ADDENDUM 1

DATE: August 2, 2018

Contract 18-C-00025; Williams Park Activity Center Expansion

SHEET NUMBER
A-4.1

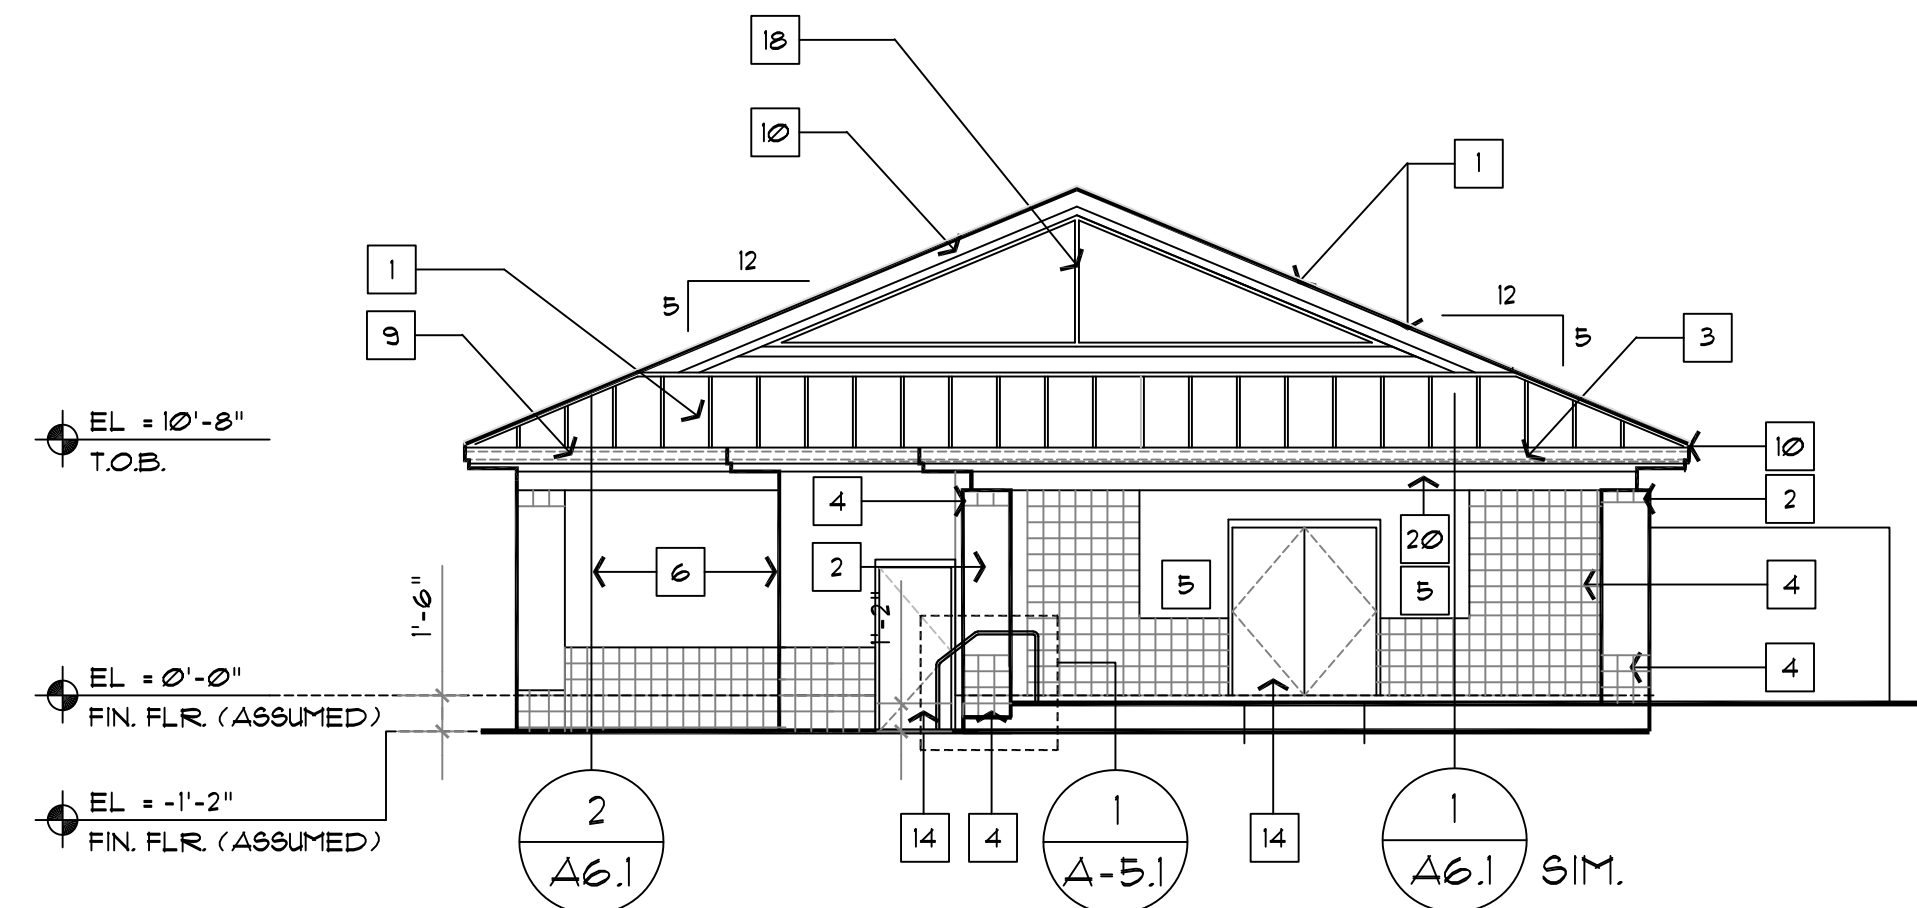
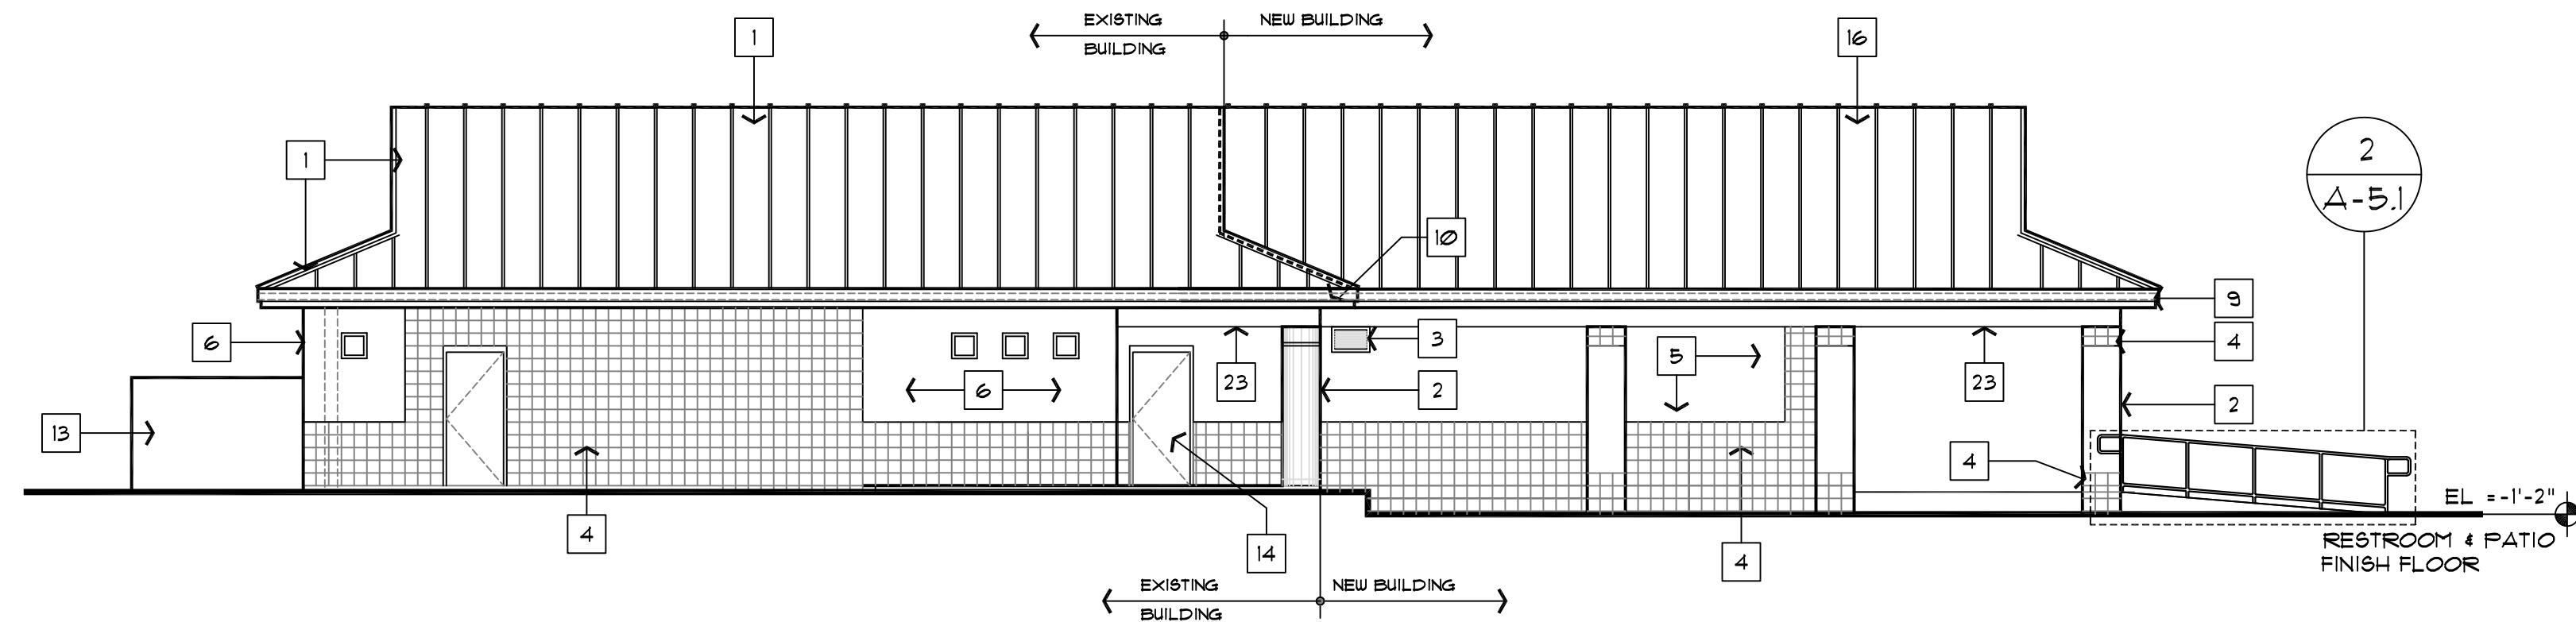
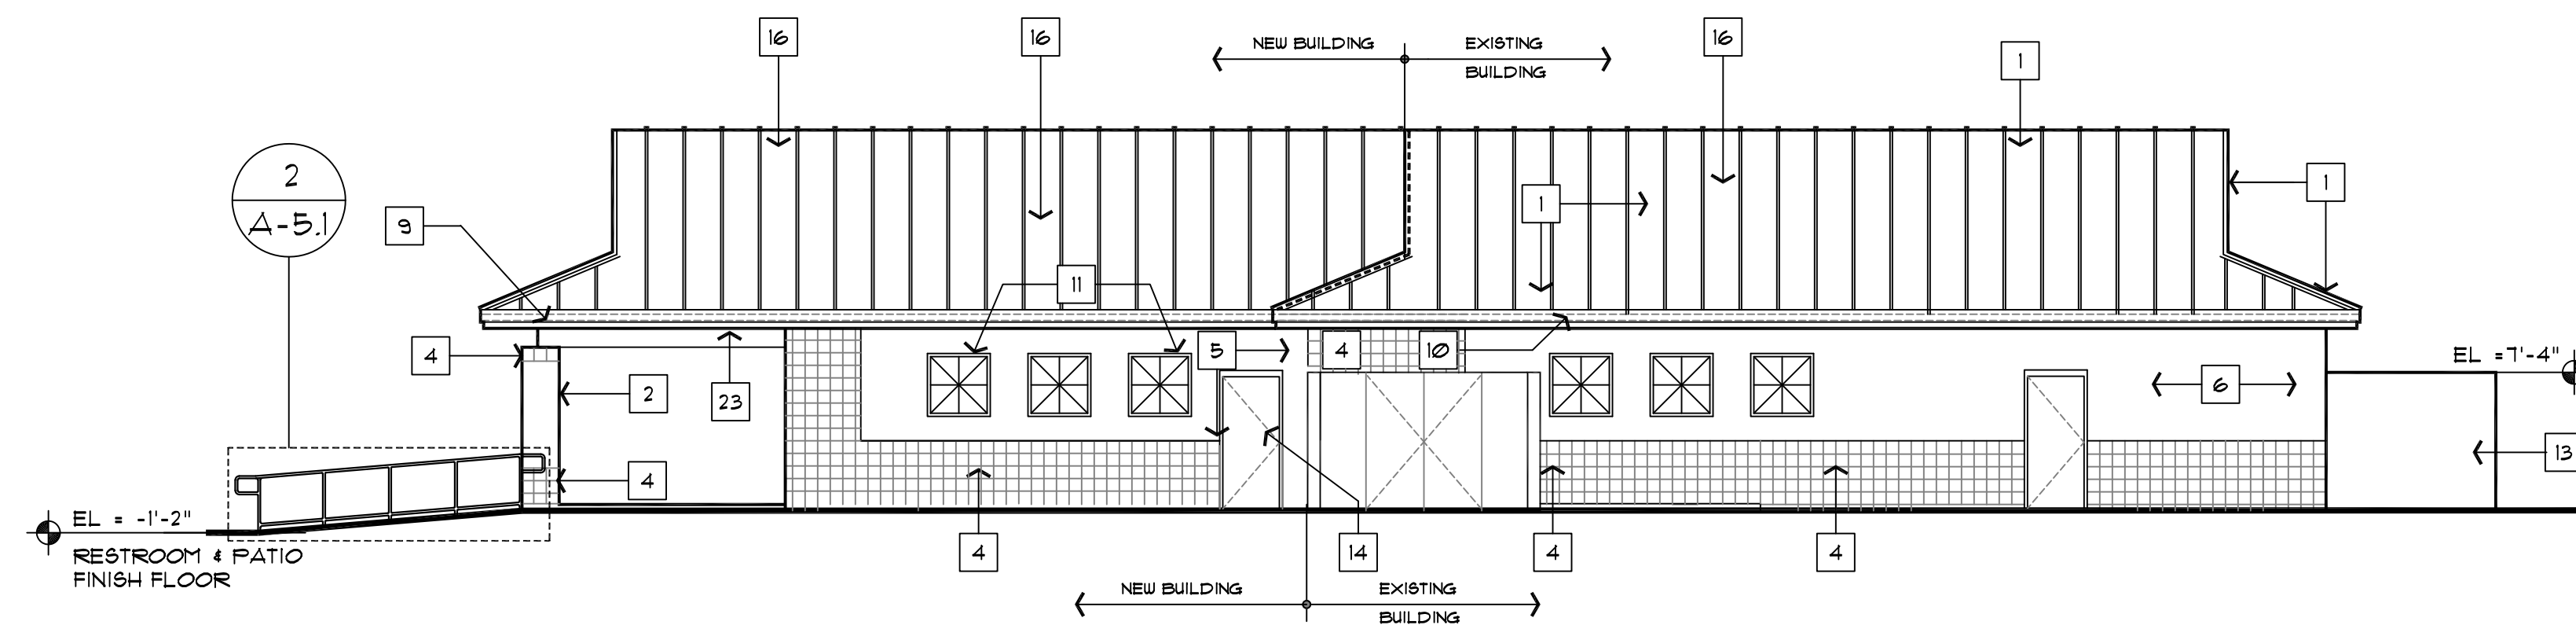
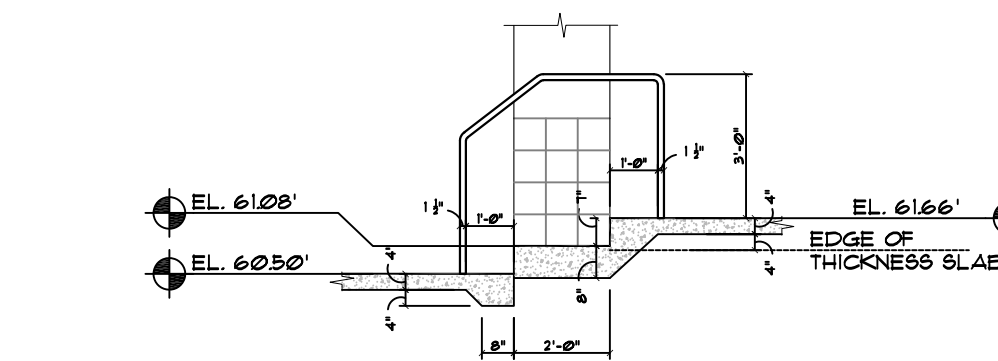
Item 6: Sheet A-5.1; Key Note 11; ADD the following: Relocate sun burst window grilles moved from existing windows per Sheet A-1.0, Key Note 12.
